PERMIT

This is to certify that KIRKWOOD LLC /Kirkwood Develop
has permission to Single Family Home 28'x34' garage
AT 440 PRESUMPCOT ST 418A A009001

ONE AND TWO FAMILY	PLAN REVIEW	CHECKLIST
Soil type/Presumptive Load Value (Table R401.4.1)		
Component	Plan Reviewer	Inspection/Date/Findings
STRUCTURAL Footing Dimensions/Depth (Table R403.1 & R403.1(1), (Section R403.1 & R403.1.4.1)	OK - 8' 10" x 20"	
Foundation Drainage Damp proofing (Section R405 & R406)	OK	
Ventilation/Access (Section R408.1 & R408.3) Crawls Space ONLY	N/A	
Anchor Bolts/Straps (Section R403.1.6)	1/2" - 6" OC - OK	
Lally Column Type (Section R407)	3 - 2x12's	OK - reduced to 5'
Girder & Header Spans (Table R 502.5(2))	Max span - 6 1/2' over	
Built-Up Wood Center Girder Dimension/Type	OK - 2x6 PT	
Sill/Band Joist Type & Dimensions First Floor Joist Species Dimensions and Spacing (Table R502.3.1(1) & Table R502.3.1(2))	2x10's - 16" OC	
Second Floor Joist Species Dimensions and Spacing (Table R502.3.1(1) & Table R502.3.1(2))	2x10's - 16" OC

CHECK-LIST AGAINST ZONING ORDINANCE

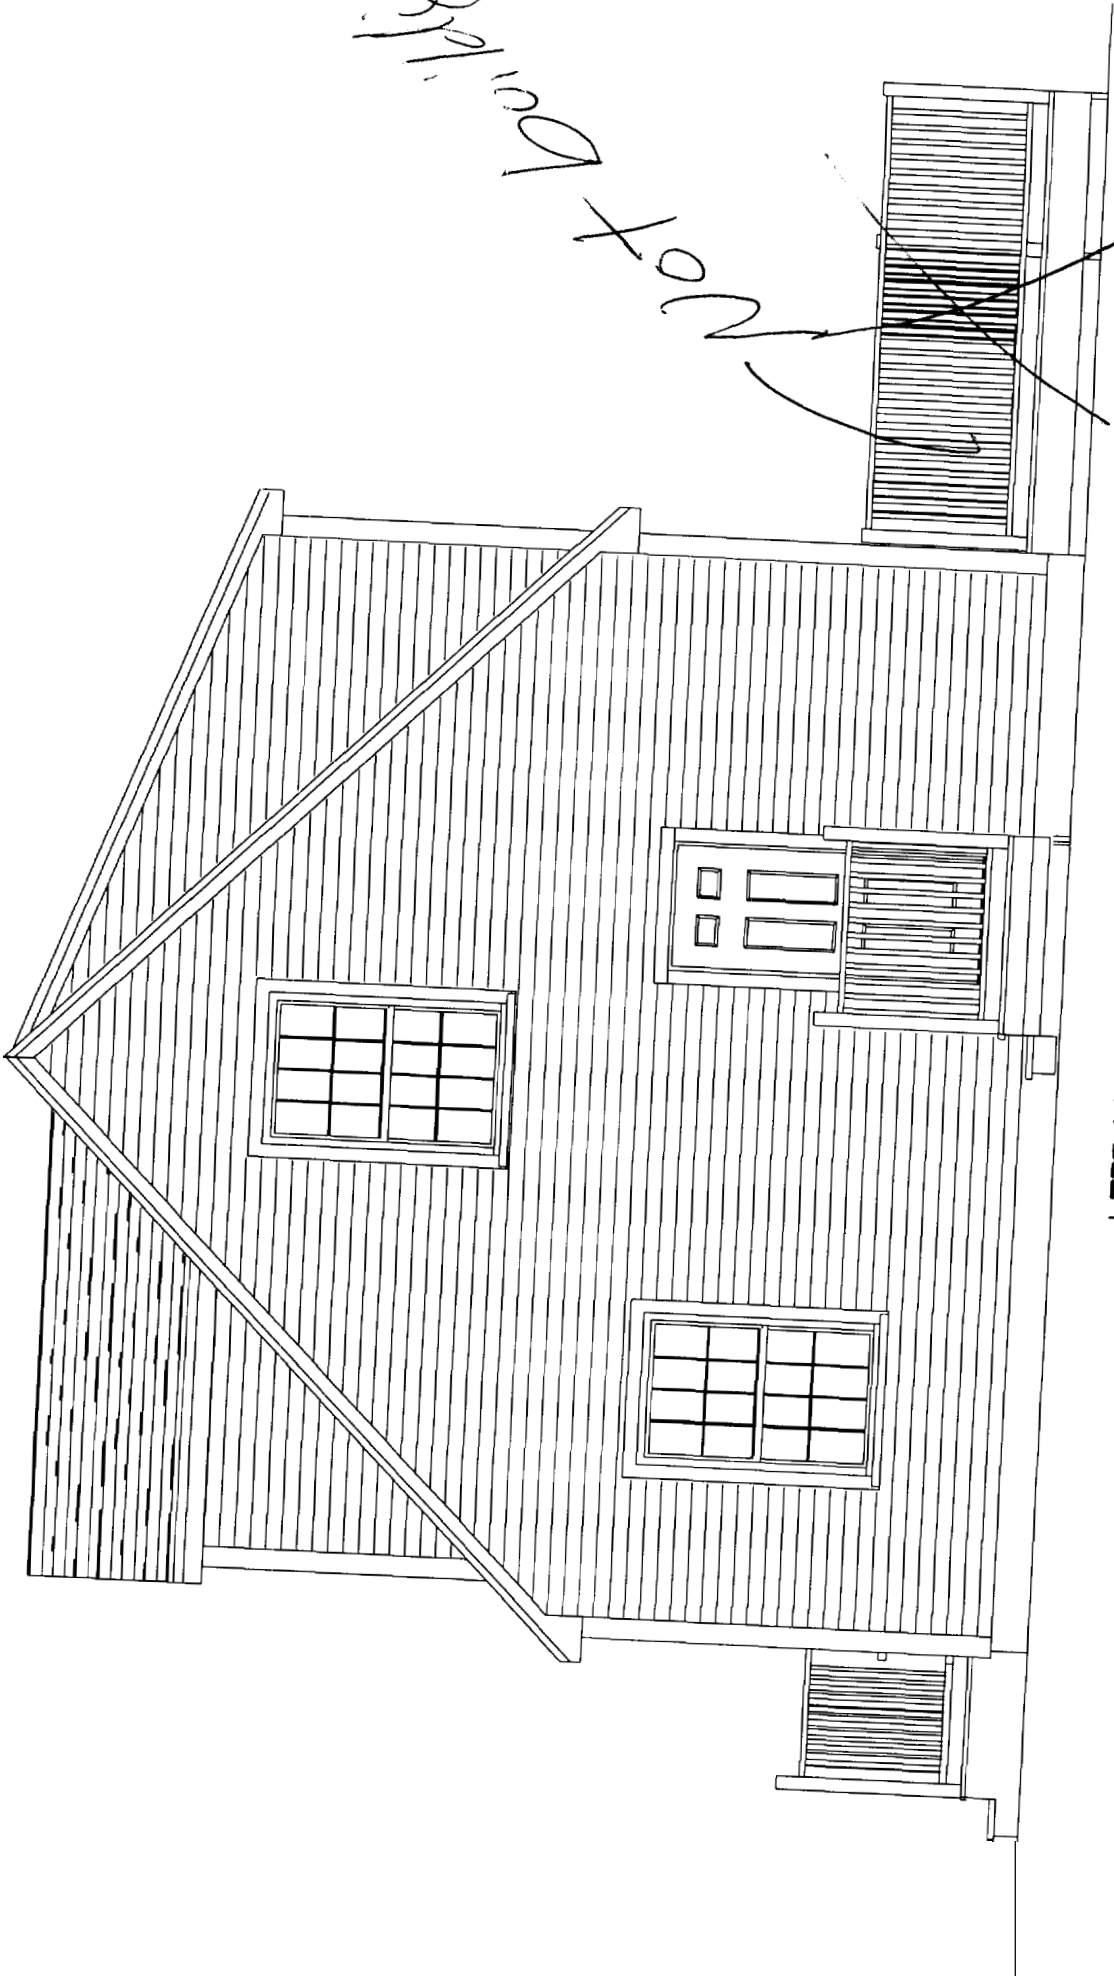
The tank must be a minimum of 10' away from the house.
